CITY OF MERCED
Planning & Permitting Division

STAFF REPORT: #17-07

SUBJECT: **Design Review #17-01**, initiated by Robert DeGrasse, on behalf of Stephen G. Tinetti and Joan M. Tinetti, Trustee. This application involves a request to develop a 5,538-square-foot car wash (Prime Shine Car Wash) on a vacant 1.7-acre parcel located at 930 W. 16th Street. The subject site is generally located on the south side of W. 16th Street, approximately 525 feet east of R Street, within a General Commercial (C-G) Zone. *PUBLIC HEARING*

ATTACHMENT B

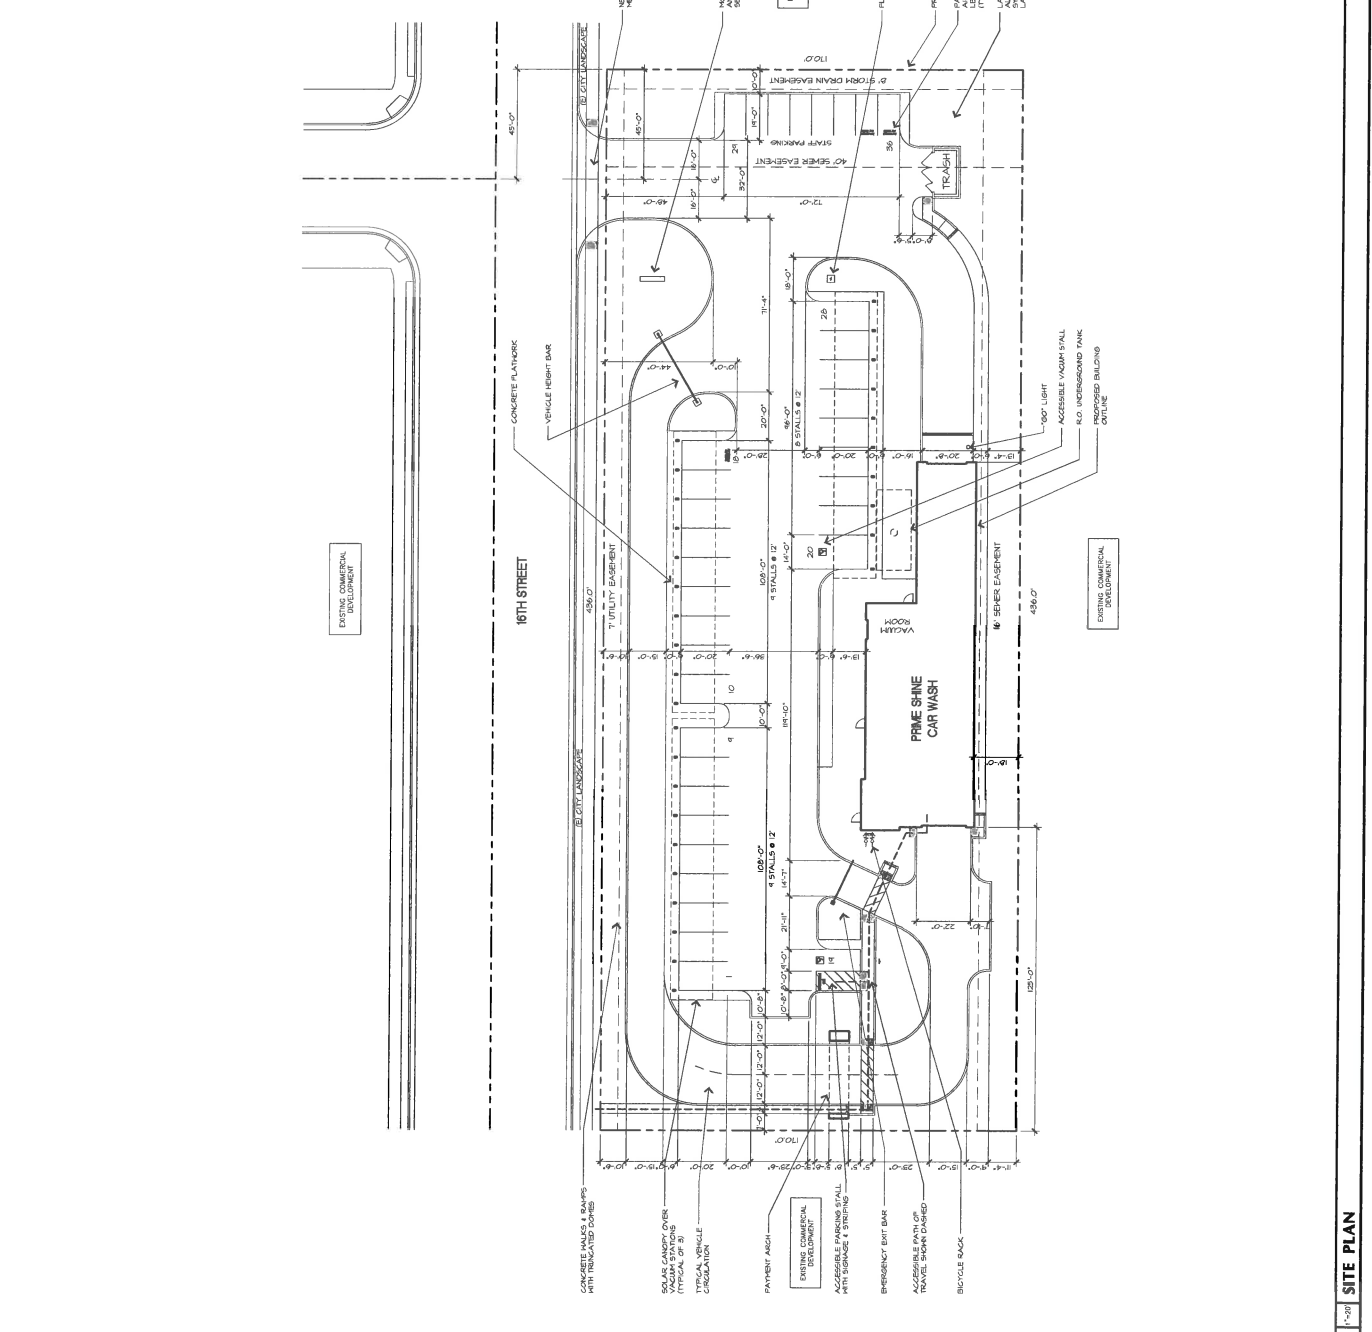
- 27) The new driveway on 16th Street shall be designed to align with P Street, or as otherwise required by the Engineering Department.

trees are required. The Landscape Plan at Attachment C shows three parking lot trees located within the western portion of the parking lot. The location of the parking lot trees may change as the Site Plan at Attachment B was recently revised to relocate the driveway 50 feet east to align with P Street. This resulted in minor changes to the parking lot layout. The applicant shall be required to provide a revised Landscape Plan during the building permit stage that shows at least one parking lot tree from the City's approved tree list (Condition #11).

ATTACHMENT E

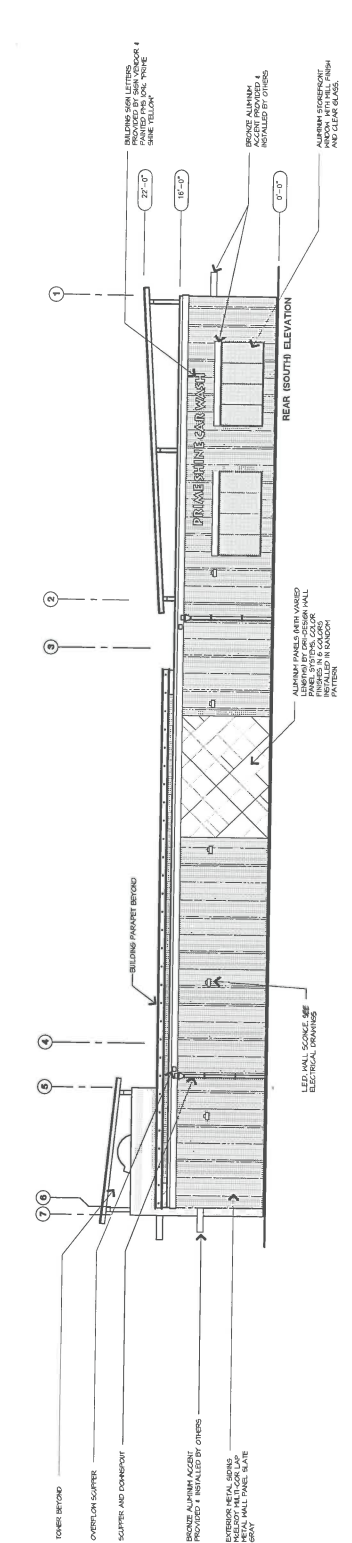
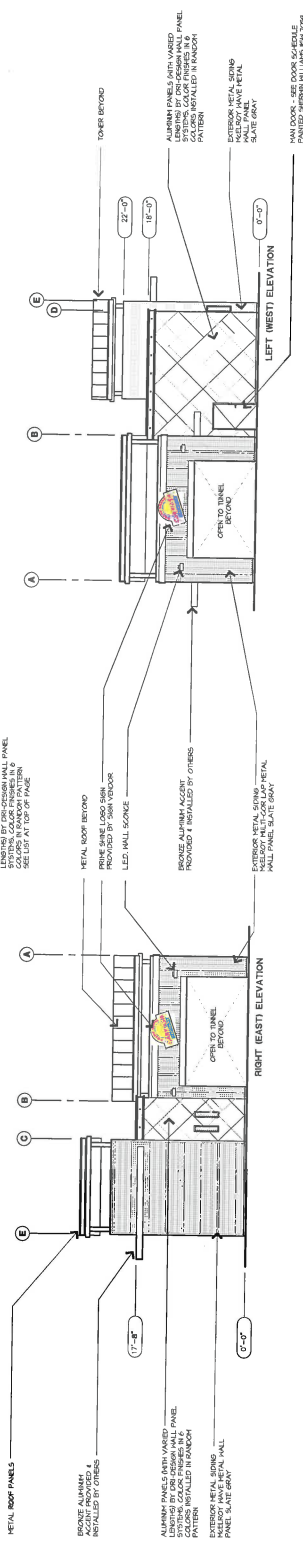
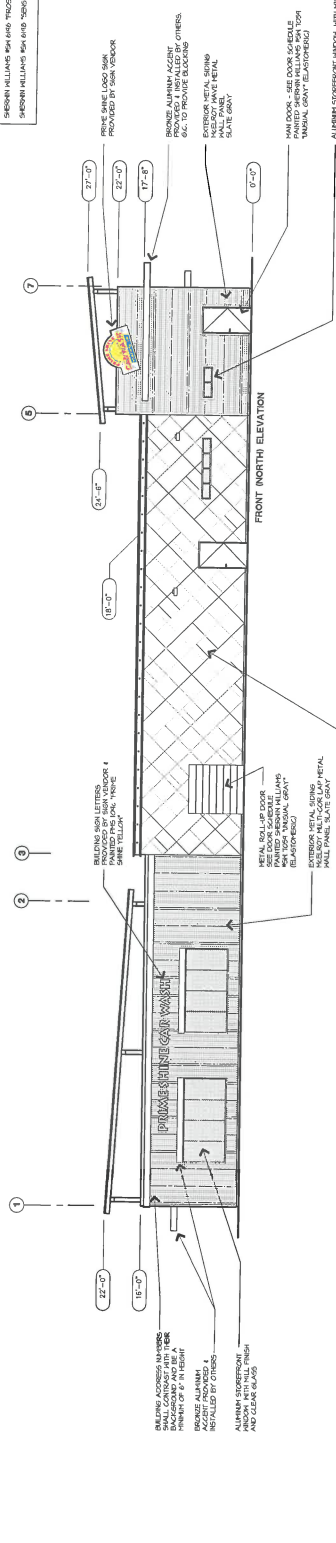
- 22) The beams below the tower roofs shall be painted a color that either matches or complements the mosaic diamond façade on the north elevation. Beam color samples shall be reviewed and approved by Planning staff during the building permit stage.

The majority of the building and solar canopies have a grey color scheme. To help break-up this monolithic color scheme, the applicant is proposing to paint the metal roof beams “yellow” or another color that matches or complements the diamond shaped panels. The colors of the beams are not shown on the renderings, but they will be reviewed and approved by Planning Staff during the building permit stage (Condition #22).
